TASMANIAN PLANNING COMMISSION

Draft Integrated Assessment Report

Macquarie Point Multipurpose Stadium Project of State Significance

31 March 2025

Figure 7.1.2.1: Likely pedestrian pinch points in the vicinity of the Stadium for 24,500+ patrons egressing

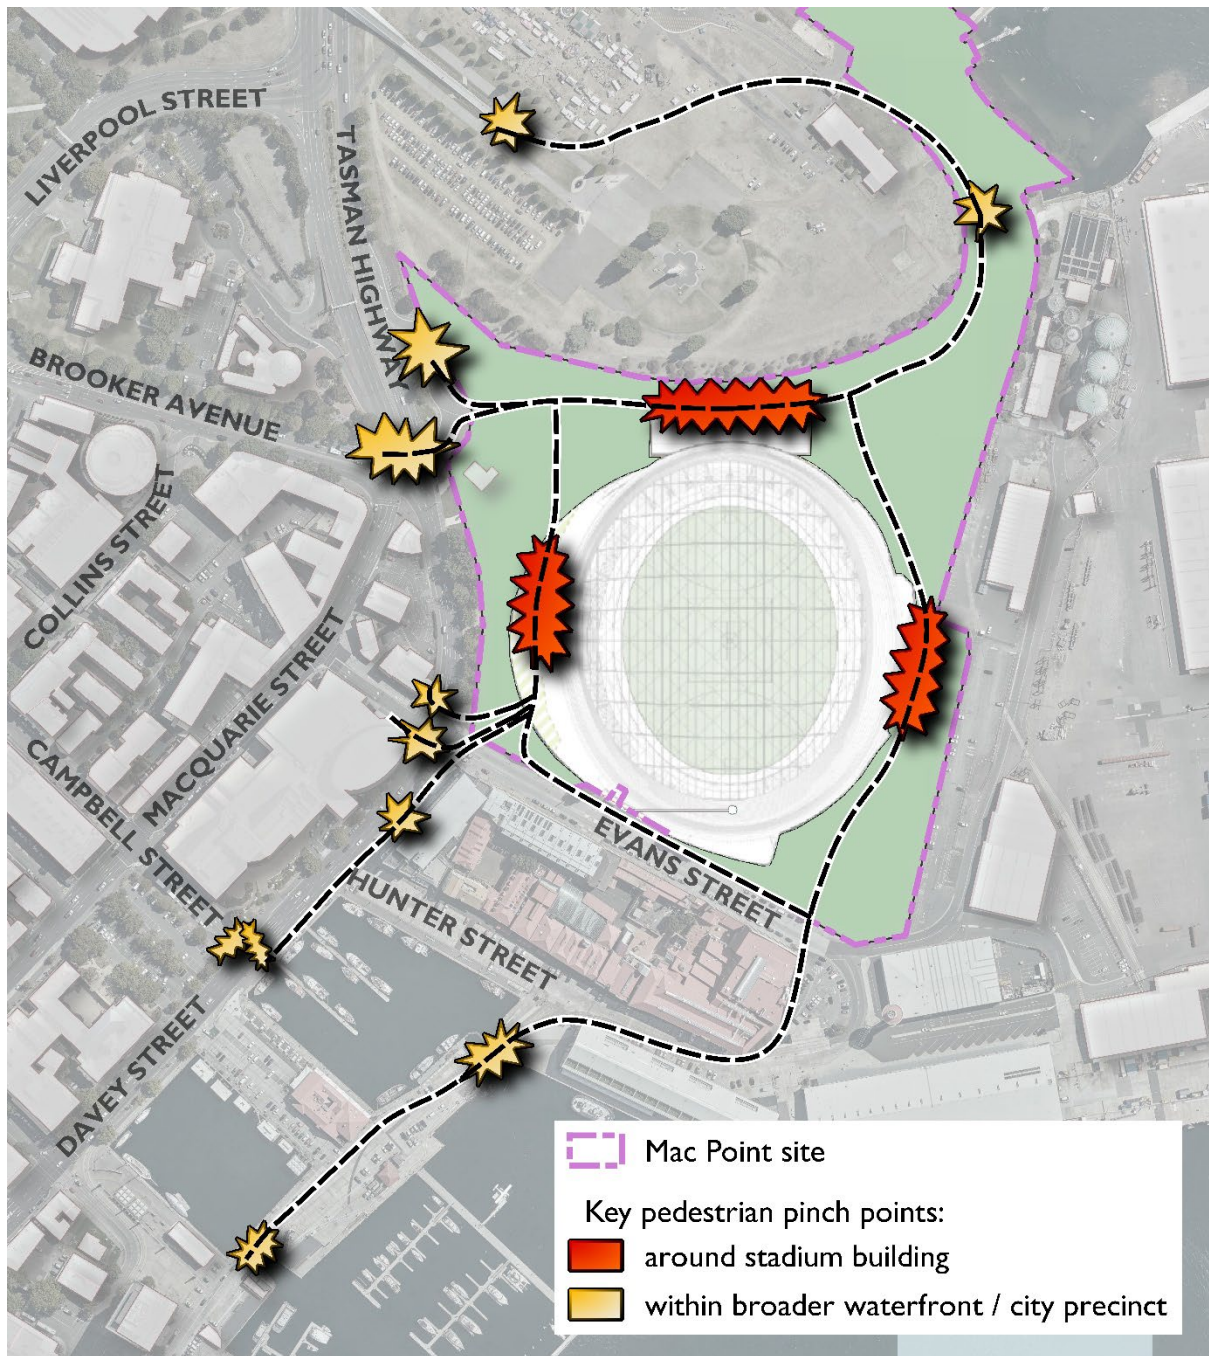
- (h) Likely key pinch points for pedestrian movement during an evacuation are shown in Figure 7.1.2.1 and include:
- movement through the bus plaza and northern access road

- movement through the ‘Aboriginal Culturally Informed Zone’
 - movement on Davey Street and Franklin Wharf footways
 - Davey Street / Tasman Highway pedestrian crossings; and

- Eastern perimeter of the stadium - particularly if the northern access road is closed to pedestrians.
